KUM & GO GAS & C-STORE

MAJOR SITE DEVELOPMENT PLAN

2232 - EL PASO, COLORADO
SECURITY BLVD. AND MAIN ST.
EXISTING CONDITIONS AND DEMOLITION PLAN

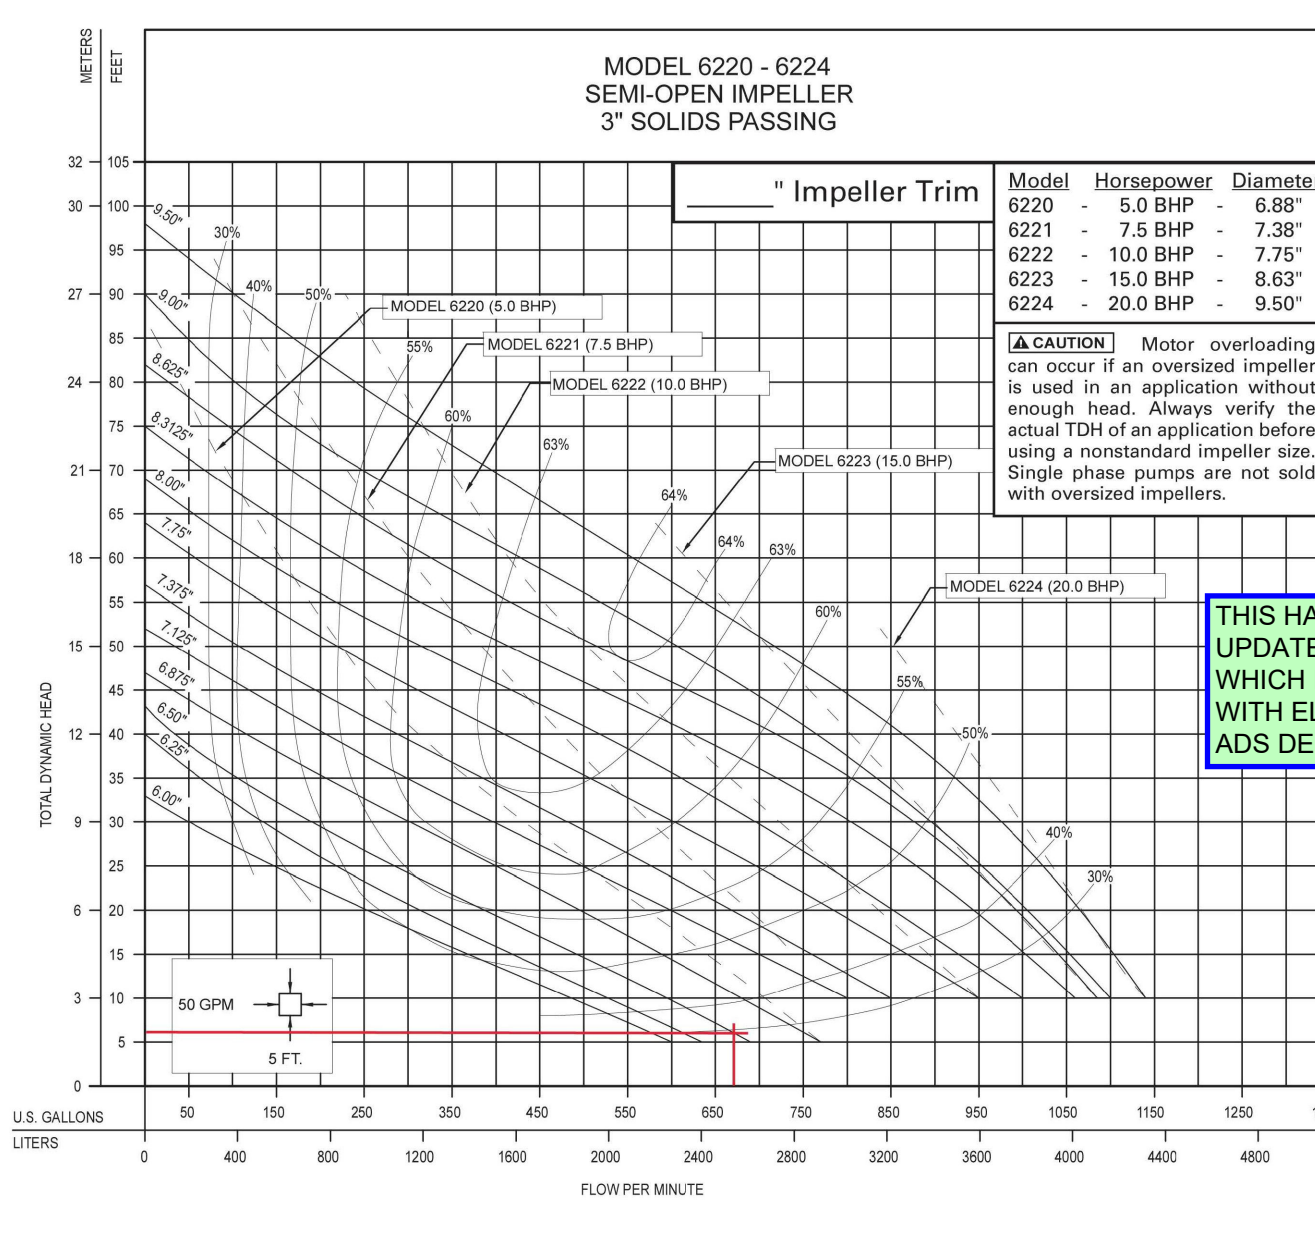
Review 4 update: the EES response above seems to contradict itself.

UNDERDRAIN IS SHOWN AND PART OF THE ADS PLAN DESIGNS.

The underdrain is not shown on the plans and is part of the underground detention system which is shown on the plans
